Rev A, April 28 2016: p/n modification, was 22855593  
now wb16-80.

## EPA Emission Control Decal Replacement 9700 (B13R)

FIG.1 CORRECT INFORMATION ON NEW EPA DECAL (2016 VEHICLE SHOWN)

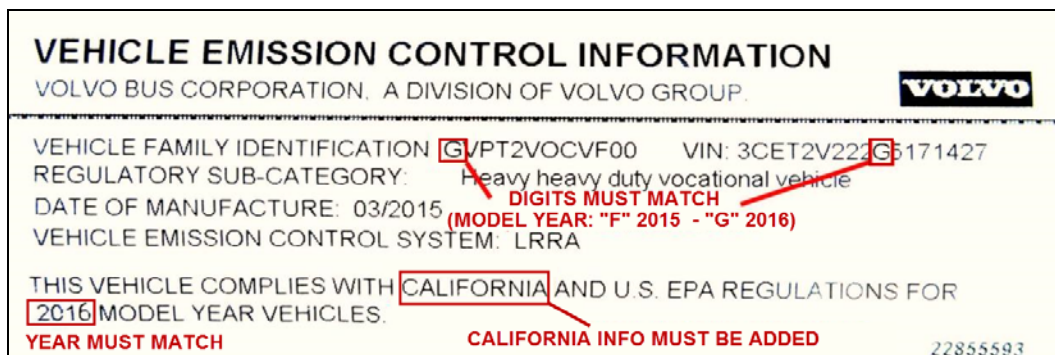
On the vehicles affected by this bulletin the EPA (US Environment Protection Agency) decal located in the engine compartment displays incorrect information related to the vehicle emission control.

Specifically, the first character, indicating the model year in the vehicle family identification number is incorrect and the California state EPA compliance notice is missing.

1. Validate that the new EPA decal information is correct:
  - Vehicle family Identification number first digit must match vehicle VIN 10<sup>th</sup> digit (see Fig 1).
  - Regulation compliance must include California (see Fig 1).
  - Vehicle VIN must match VIN on the new decal (see Fig 2).
